Access Compliance Report

Public Rights-of-Way

(Curb Ramps)

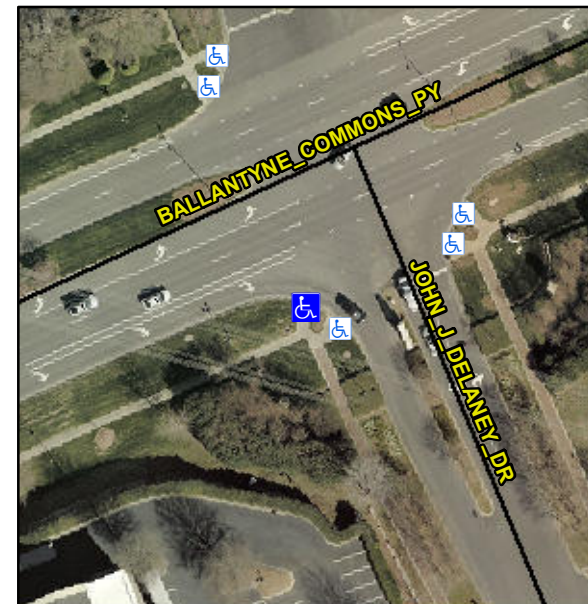
Intersection ID: 27468	Main Street: BALLANTYNE COMMONS PY	Cross Street: JOHN J DELANEY DR	Location: SW
ADA ID: 32988AAD7A45	Ramp Type: Perp	Initial Pass/Fail: Fail	Overall Compliance: No
Severity Score: 13.75			
Codes/Mitigation Info/Possible Solution		Field Measurements/Component Compliance

R304.2.2, R304.5.3

Compliance	Description	Data	Compliance	Description	Data
N/A	Ramp Length (in)	134.0	No	Ramp Slope (%)	8.7
Yes	Ramp Width (in)	48.0	No	Ramp XSlope (%)	2.7
N/A	Flare Type LT	N/A	N/A	Flare Type RT	N/A
N/A	Flare Slope LT (%)	N/A	N/A	Flare Slope RT (%)	N/A
N/A	Flare Traversable LT?	N/A	N/A	Flare Traversable RT?	N/A
N/A	Landing Length (in)	N/A	N/A	DWS Provided?	N/A
N/A	Landing Width (in)	N/A	N/A	DWS Contrast?	N/A
N/A	Landing Slope (%)	N/A	N/A	DWS Length (in)	N/A
N/A	Landing X Slope (%)	N/A	N/A	DWS Full Width?	N/A
N/A	Landing Curb? (Y/N)	N/A	N/A	DWS Offset (in)	N/A
N/A	Shared Landing?	N/A			
N/A	Gutter Ponding?	N/A	N/A	Gutter Slope (%)	N/A
N/A	Gutter Lip Ht (in)	N/A	N/A	Gutter X Slope (%)	N/A
N/A	Painted X Walk1?	No	N/A	Painted X Walk2?	N/A
	X Walk 1 Direction	To NW		X Walk 2 Direction	N/A
N/A	X Walk 1 Width (in)	N/A	N/A	X Walk 2 Width (in)	N/A
	X Walk 1 Slope (%)	1.0		X Walk 2 Slope (%)	N/A
	X Walk 1 X Slope (%)	0.8		X Walk 2 X Slope (%)	N/A

Remove & Replace Entire Ramp.
